**LOS ALAMOS TECHNICAL EVALUATION REPORT**

**On-Site Audit of Duane Arnold Energy Center Emergency Core Cooling System  
Strainer Blockage Resolution**

**November 1999**

Fig. 1. Plan view of ZOI (magenta) superimposed on affected piping systems (yellow) within the drywell (red).

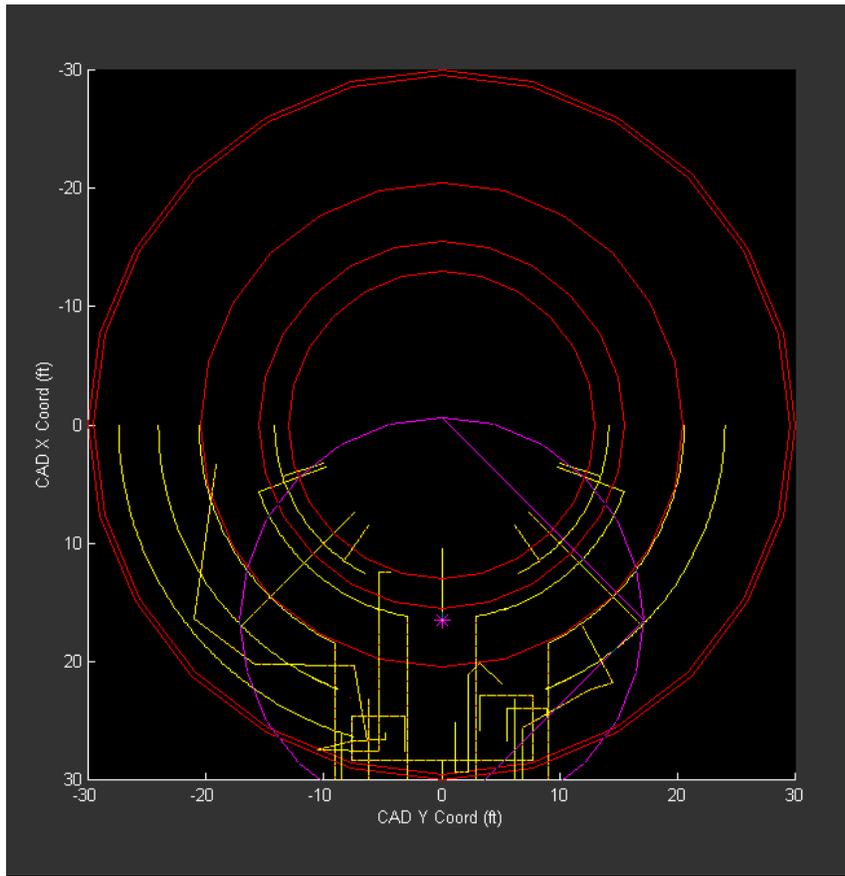
Based on a visual examination of plant drawings, Los Alamos confirmed that the postulated break is located in the area of highest fibrous insulation density and that the location chosen by the licensee includes all major reactor-piping systems. This location is same as the location represented by weld RCA-J006 in the NUREG/CR-6224 study. (Note: The break postulated at RCA-J006 generated the largest quantity of debris in the NUREG/CR-6224 study). The Los Alamos analysts agree with the licensee selection of the break location.

Los Alamos scientists calculated the volume of Nukon debris using the plan and elevation drawings provided by the licensee. These drawings provided spatial coordinates that could be easily entered into an automated debris generation model that computes piping intersections for spherical ZOI with sizes determined by break diameter. Several stylized views of the piping data within the containment boundaries are provided in Figs. 1–4; a typical 10-psi ZOI for a break in the RCA line also is shown. It should be noted that only piping in the vicinity of the ZOI is included in the model because the region of highest congestion was predetermined by visual inspection. This location is consistent with the observations in NUREG/CR-6224. Break locations were postulated at 1-ft increments along the vertical length of the 22-in.-o.d. RCA line. The maximum debris generated is 427 ft<sup>3</sup>, which is lower than the licensee estimate of 544 ft<sup>3</sup>. The reason for the difference is that licensee conservatively included piping segments that are not the periphery of the ZOI. LANL included targets that are part of the ZOI.
